STAFF REPORT: 12-10-2025 REGULAR MEETING

APPLICATION NUMBER: HDC2025-00723

ADDRESS: 84 EDMUND PLACE

SCOPE: REVISE FAÇADE/WINDOWS (*REVISION TO PREVIOUSLY APPROVED DESIGN*)

December 2022 design, as approved with conditions. Main façade, above. Non-primary elevations visible below.

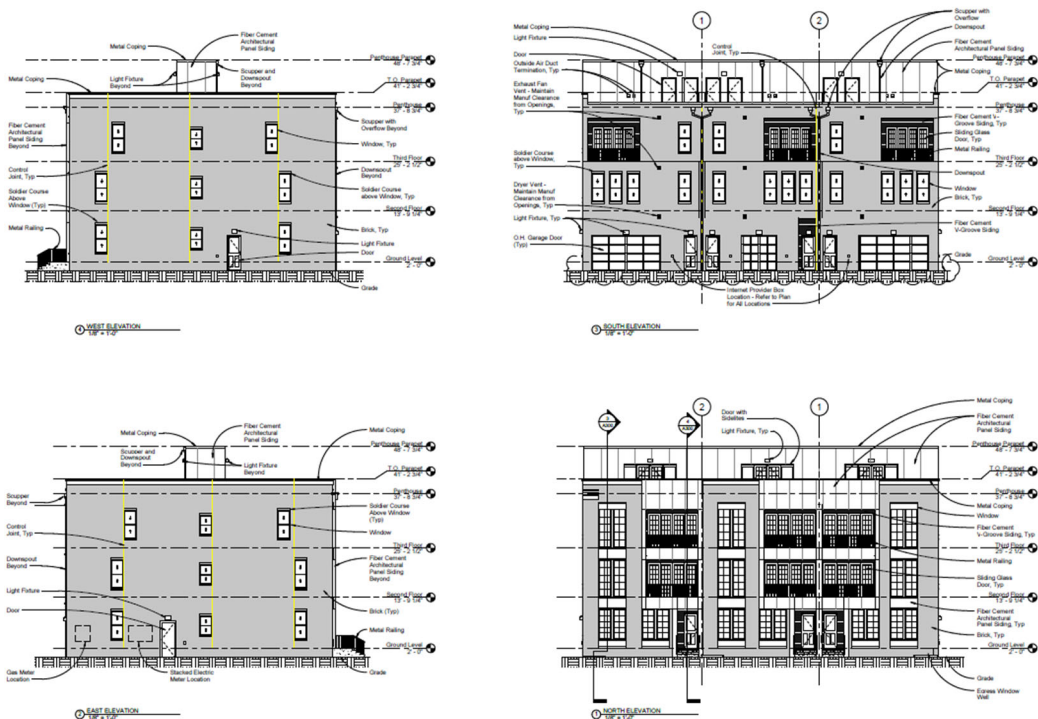
The project was approved with a condition that *“the design be further developed at the non-primary elevations consistent with input from PDD Design Review and Historic staff. Upon receipt of an updated design, staff may approve the revisions for permit if consistent with the Elements of Design and the Secretary of the Interior’s Standards, or return the design to the Commission for further review if necessary.”*

This design condition was proposed by staff in the 2022 staff report, and adopted by the Commission in their decision, to address concerns about the “lack of adequate texture and articulation” in the non-primary elevations, making them seem “flat and disconnected.” Staff had recommended that “while these exposures would not have to be as well-developed as the primary facades, certain textures, shadow lines and other elements present at the front should be carried around to the sides and rear.” Importantly, staff further opined that *“there may be a number of different ways to accomplish this in a modern spirit, including the addition of materials and detailing present on the main facades, more deliberate recess and framing of window openings, adding additional paired openings, etc.”* However, the explicit conditional language in the COA did not apparently allow staff to approve revisions at the front (primary) elevation, beyond the “minor changes” typically allowable.
